国際放射線防護調査（平成 25 年度）	i
委員構成	v
第 1 章 IAEA 国際安全基準委員会等の活動について	1
1. 放射線安全基準委員会（RASSC）	2
1.1 第 34 回 RASSC 会合、第 35 回 WASSC 合同会合について	2
(1) RASSC 会合 Draft Agenda	2
(2) RASSC 会合 Agenda（解説版／対処方針案）	8
(3) 出席報告	17
1.2 第 35 回 RASSC 会合、第 36 回 WASSC 合同会合について	29
(1) RASSC 会合 Draft Agenda	29
(2) RASSC 会合 Agenda（解説版／対応方針案）	34
(3) 出席報告	40
1.3 主な審議結果	53
(1) 第 34 回 RASSC 会合、第 35 回 WASSC 合同会合	53
(2) 第 35 回 RASSC 会合、第 36 回 WASSC 合同会合	56
1.4 その他関連委員会および国内対応会合について	59
(1) 廃棄物安全基準委員会（WASSC）、国内対応会合	59
(2) 安全基準委員会（CSS）	61
第 2 章 IAEA 安全基準文書案について	62
2.1 今年度 RASSC 会合で扱う安全基準文書策定概要書および安全基準文書案	62
(1) 安全基準文書策定概要書	62
(2) 安全基準文書案	63
(3) 加盟国コメント照会文書	64
2.2 IAEA 安全基準文書案（RASSC 主管）について	64
(1) 原子力、放射線の緊急事態に関連する安全基準文書案	64
(2) 安全指針文書（step7：1 次ドラフト検討）	69
(3) 安全指針文書（step11：2 次ドラフト検討）	76

国際放射線防護調査（平成25年度）

・議題 RW6.5 安全指針 DS458「消費者製品の放射線安全」

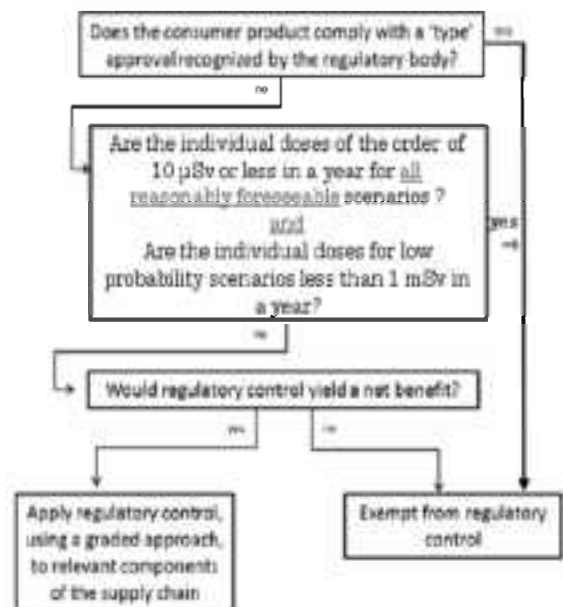
なお、図 3.2 の前回日本からコメントした $10\mu\text{Sv/y}$ を超え、なおかつ低確率事象での 1mSv/y を超えない場合に免除になるという問題について、会議終了後に米原氏からコメントしたが、その後の E-メールによる事務局とのやりとりで、日本の図の改定案(以下)を採用するとの回答があった。

本文書案に対し、日本から図 3.2 の BSS との不整合についてコメントして、採用されたことの回答を得ていたが、最新のドラフトで反映されていないことを確認し、第 35 回 RASSC 会合において指摘を行った。その結果、第 34 回 CSS 会合の審議文書において、図 3.2 の訂

No.3	Fig.3.2	The process including meanings of all scenarios and low probability scenarios shown in Fig.3.2 should be described in the text.	The definition of terms such as "a range of normal usage and realistic accident scenarios,"(3.33) or "all reasonable foreseeable circumstances...low probability scenarios," (2.22, quoted BSS) is not described. It is not clear if all scenarios include low probability scenarios.	回答なし	Proposed new textにマーカー (p22)
No.5	ANNE X I~III	Each annex should be quoted properly in the associated chapter of this document.	Clarification	A	Text referring to each annex is added to the relevant section (p37)

No.4	Fig.3.2	To be modified Fig 3.2 <pre> graph TD Q1{Does the consumer product comply with a 'type' approval recognized by the regulatory body?} Q2{Are the individual doses of the order of 10 µSv or less in a year for all reasonable foreseeable scenarios? and Are the individual doses for low probability scenarios less than 1 mSv in a year?} Q3{Would regulatory control yield a net benefit?} A1[Apply regulatory control, using a graded approach, to relevant components of the supply chain.] A2[Exempt from regulatory control.] Q1 -- no --> A1 Q1 -- yes --> Q2 Q2 -- no --> A1 Q2 -- yes --> Q3 Q3 -- yes --> A1 Q3 -- no --> A2 </pre>	In the original figure, there is a possibility that consumer goods which do not fulfill the first criterion (10 µSv/y) may be exempt when it meet the second criterion (<1mSv/y).	A	This is the correct interpretation of the BSS.
------	---------	---	---	---	--

正を確認した。図 3.2 へのコメント以外は、追加すべき点はないとして、追加の検討課題の報告は行わないこととした。

- DS458について、第35回CSS会合の検討資料を確認し、我が国から提出したFig. 2 (旧図3.2) へのコメントが反映されていることを委員会事務局から報告した。
- 第6回国際専門家会合 (IEM6) が、2014年2月17日～21日にウィーンで開催された。「福島第一事故後における放射線防護 - 信頼と理解の促進に向けて - 」と題し、別用務で出席した川上 (原安協) から、概要について報告があった。IAEAのPinak氏から、現在の放射線防護に関する安全規制の問題点について、規制値が多すぎることと、システムが複雑であることなど発表があり、チェルノブイリ発電所で新たなシェルター建設において、作業員の線量管理に関する新しい報告があったことなどが紹介された。
